SS - 3121 FTL 2023 P4 New Cascadia Detroit FWS Serviceability

P4 New Cascadia vehicles specified with Detroit-Racor Fuel Water Separator and Adaptive Power Steering built since 10/8/2021.

Figure 1. Current Detroit-Racor and FWS- APS Wiring Bracket affecting serviceability.

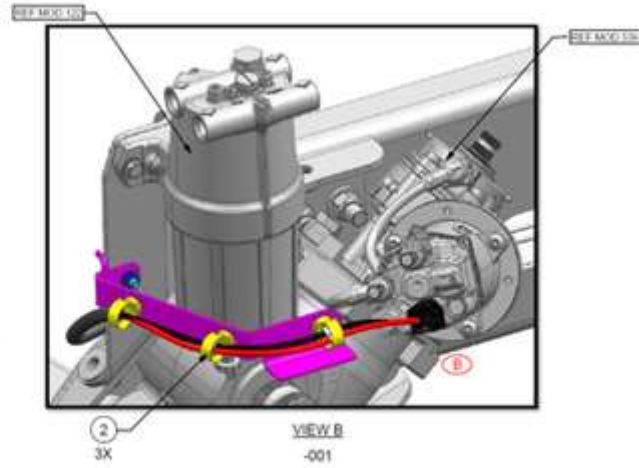
New Cascadia vehicles specified with Detroit - Racor Fuel Water Separators and Adaptive Power Steering (APS) may have reduced access to service the Fuel Water Separator due to the location of the APS Wiring bracket. Figure 1 shows the current installation of the FWS - APS Wiring and the limited space available for servicing the FWS Assembly-bowl.

In order to improve the serviceability of the Detroit FWS, the mounting-location of the APS Wiring mounting bracket needs to be relocated to provide better access to the FWS bowl.

Figure 2. Detroit FWS mounting with APS Wiring mounting bracket, affecting serviceability of FWS.

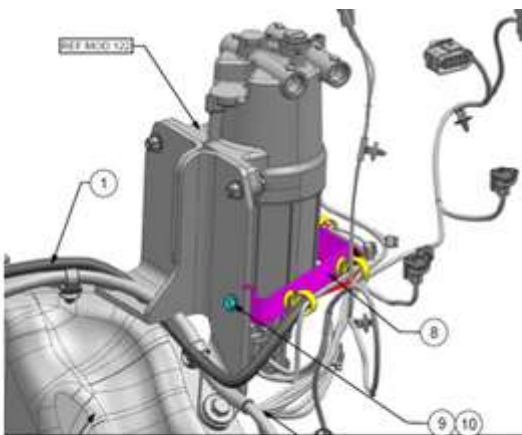
- Disconnect the APS Wiring connectors
- Remove the APS Wiring mounting Bracket Bolt/Nut, Items 9 and 10 in Figure 2.
- Drop down the APS Wiring - Bracket to open space to access the FWS mounting bracket.

- Mark and drill an additional hole position as shown in Figure 3.
